Nebraska Public Power District
Nebraska's Energy Leader

NLS2000075
February 15, 2001

Subject: Proposed License Amendment
Cooper Nuclear Station, NRC Docket 50-298, DPR-46

Title: Removal of Railroad Tracks from Figure 4.1-1, Site and Exclusion Area Boundaries and Low Population Zone.

Figure 4.1-1 (page 1 of 1)
Site and Exclusion Area Boundaries
and Low Population Zone

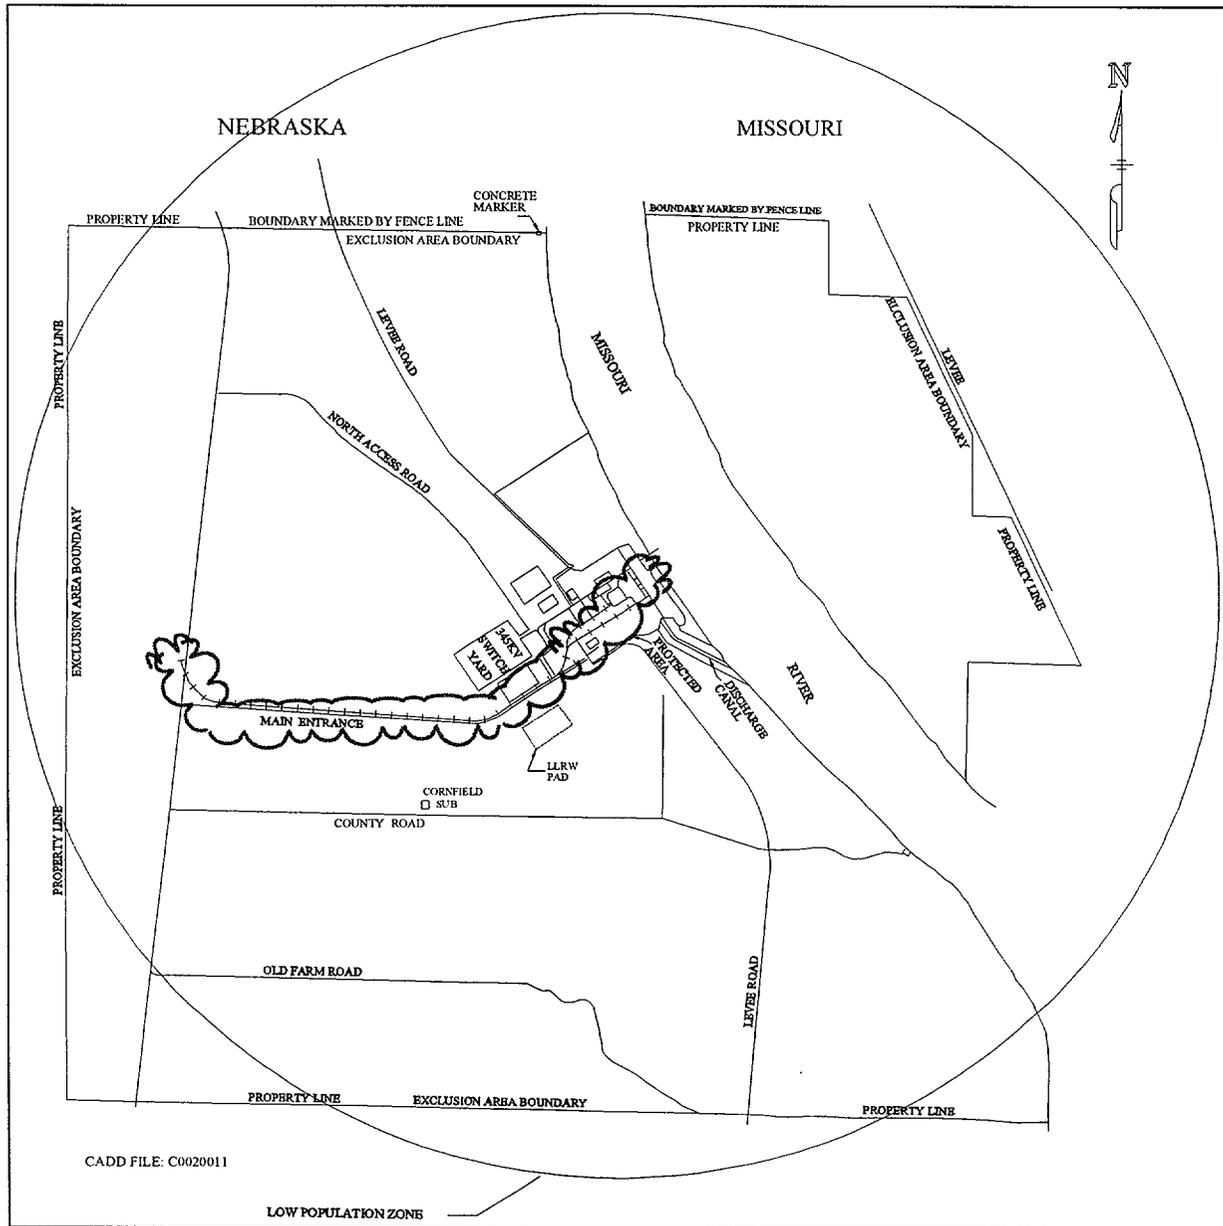
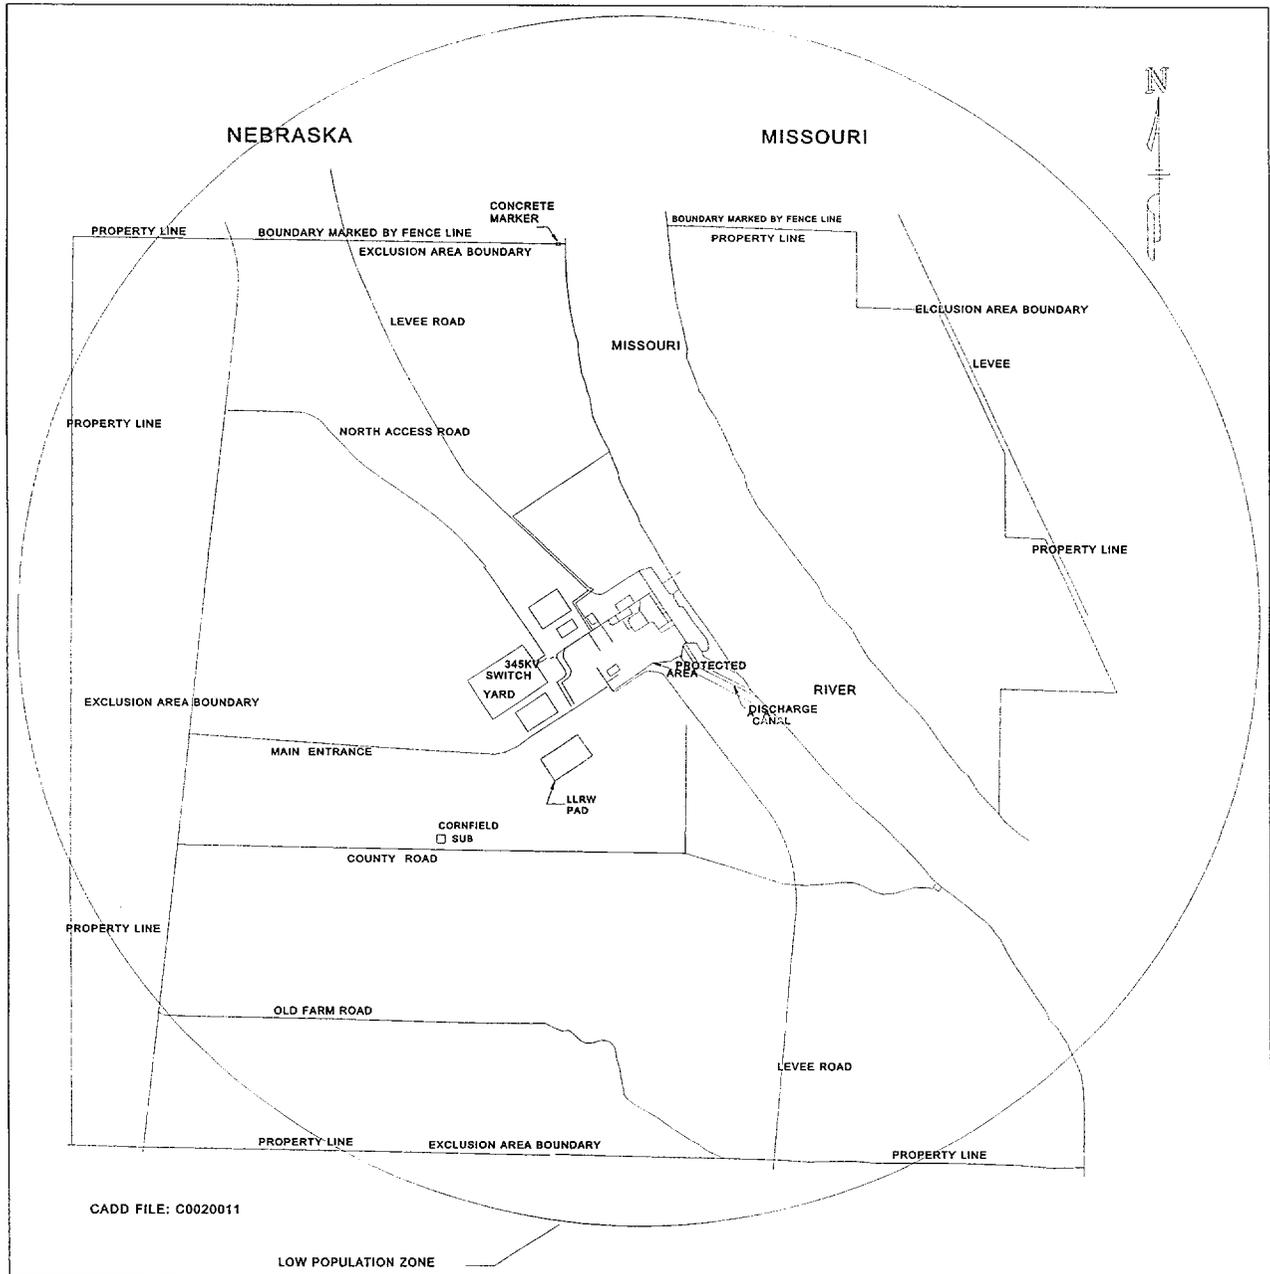
The proposed change would revise Technical Specifications Figure 4.1-1, "Site and Exclusion Area Boundaries and Low Population Zone" for Cooper Nuclear Station (CNS) to remove the depiction of railroad tracks along the main entrance road and into the plant and would change the text font within the figure for readability.

The rail line depicted in Figure 4.1-1 (Attachment 5) is a spur from the rail line to the CNS site used to provide transportation of heavy freight into and from the site which has since been abandoned in place. The figure shows the rail line next to the Main Entrance road as a cross hatched line which then splits into 3 branches that cross the Protected Area perimeter. The rail line is no longer used and serves no plant operational or safety function. Thus, it adds no significant information to the figure. This change proposes to remove depiction of these tracks from Figure 4.1-1. To improve readability,

especially for photocopies, this change also proposes to change the font of text within the figure to lettering without serifs. The proposed annotated TS page change, and final revised figure are included as Attachments 5 and 6.

In conclusion, the District requests the NRC to revise TS Figure 4.1-1, "Site and Exclusion Area Boundaries and Low Population Zone" to remove the depiction of railroad tracks along the main entrance road and into the plant, and change the text font within the figure for readability. The proposed change allows safe operation because it does not alter any safety systems, features nor analyses used in the design of the plant. Neither does it alter physical security or emergency provisions. Therefore, the District concludes that the activities associated with the above described changes present no significant hazards consideration under the standards set forth in 10 CFR 50.92 and accordingly, a finding by the NRC of no significant hazards consideration is justified.
